TSB150180
-----------

## Technical Service Bulletin

New Low Pressure Regulator Fuel Control Cover

Figure 1, Low Pressure Regulator Fuel Control Cover Malfunction Identified by Signs of Moisture

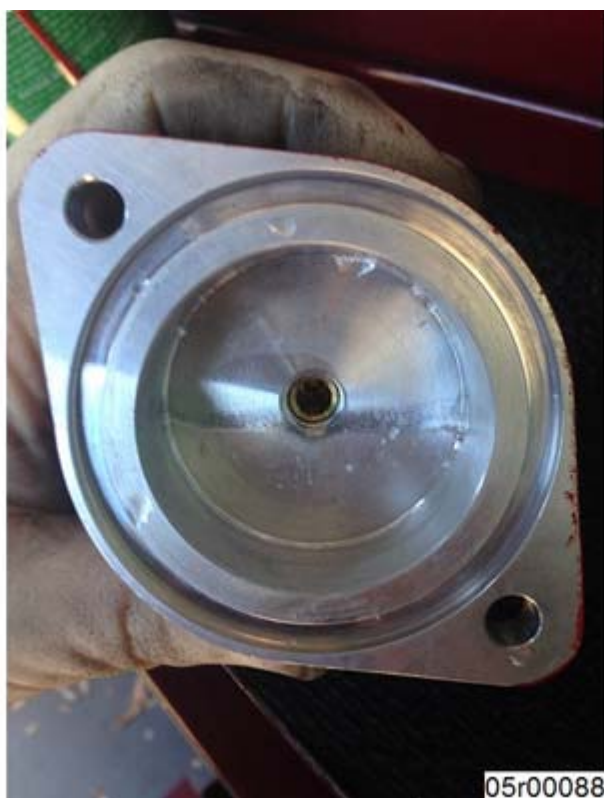
The low pressure regulator can collect condensation from the charge air cooler through the boost reference line. If the level of water reaches the reference port in the low pressure regulator, the low pressure regulator can freeze after the engine is shut down in ambient conditions below 0°C [ 32°F ].

1. Connect INSITE™ electronic service tool.
2. Check for fuel pressure Fault Codes 2722, 2723 and/or 2991.
3. If active or inactive fuel pressure fault codes are present, verify with the operator that the check engine light and/or rough running symptoms occurred at initial startup when ambient conditions were below 0°C [ 32°F ].
4. If the symptoms and fault codes occurred when ambient conditions were below 0°C [ 32°F ], remove the low pressure regulator fuel control cover.
  - o See ISL G CM2180 Service Manual, Bulletin 4021649. Refer to Procedure 005-047 in Section 5.
  - o See ISX12 G CM2180 EJ Service Manual, Bulletin 4310682. Refer to Procedure 005-047 in Section 5.
5. Check for moisture or signs of moisture in the low pressure regulator fuel control cover. See Figure 1 below.

Low pressure regulator fuel control cover, Part number 5347803, has been released to prevent moisture from entering the boost reference side of the low pressure regulator. The boost reference line fitting has been relocated to the bottom of the new low pressure regulator fuel control cover, which will prevent water pooling inside as shown in Figure 1 above.

If all conditions have been met, replace the low pressure regulator fuel control cover with new part number 5347803.

Figure 2, New Low Pressure Regulator Fuel Control Cover, Installed on ISL G CM2180 EJ Low Pressure Housing

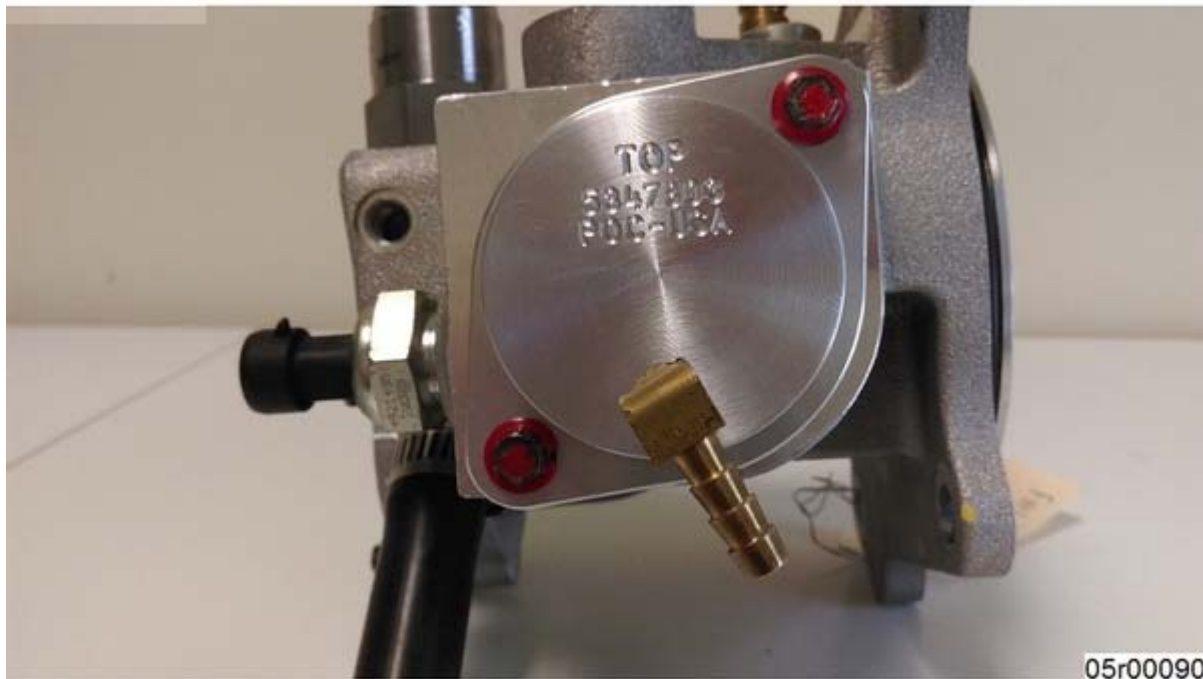
The low pressure regulator fuel control cover **must** be installed with the boost reference line fitting at the bottom. See Figure 2 and 3 below.
